SEWAGE DISPOSAL SYSTEM
HOWARD COUNTY HEALTH DEPARTMENT
BUREAU OF ENVIRONMENTAL HEALTH
410-313-2640

P 515300

A REPAIR

SUBDIVISION _____ LOT NUMBER _____ ADDRESS 280 E Watersville Road

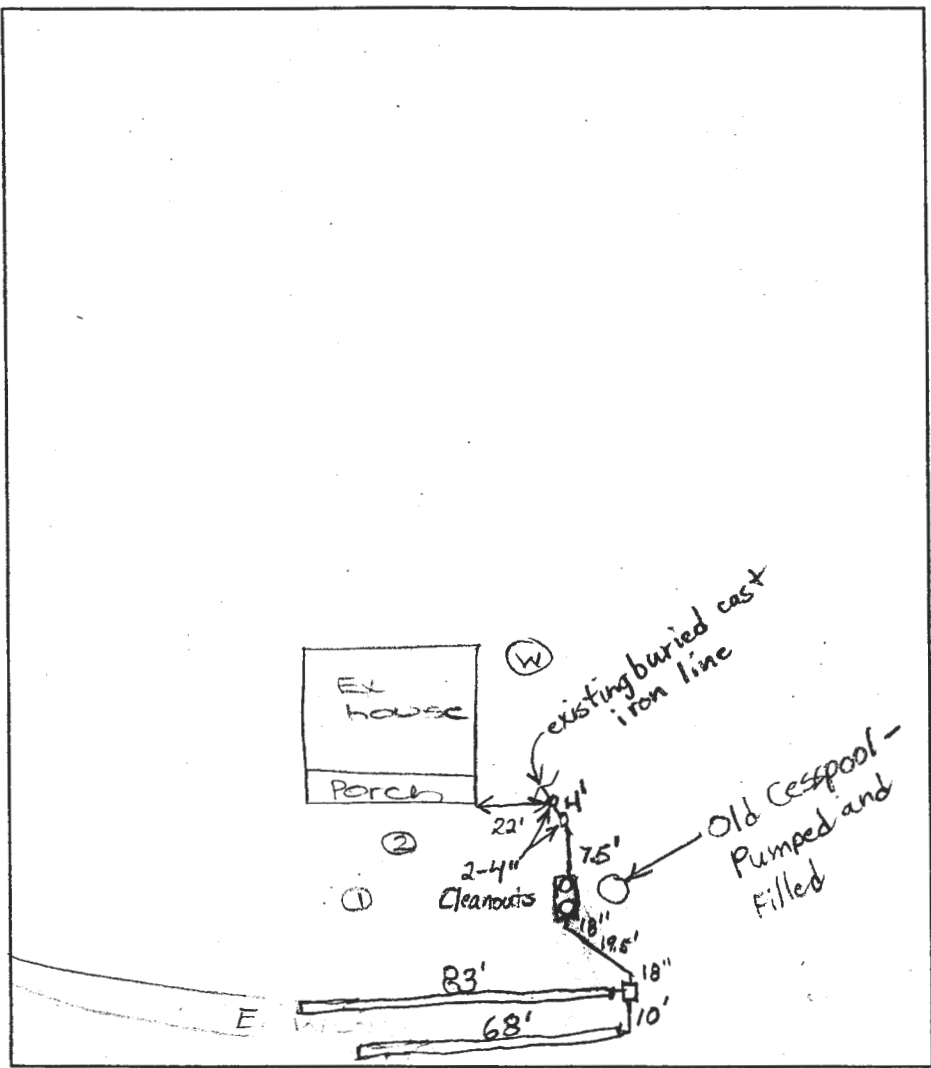
INSPECTION COMMENTS: 8/8/01 System satisfactory. Plastic septic tank and infiltrators used. Old cesspool pumped and filled with dirt. O.K. to cover. (BB)
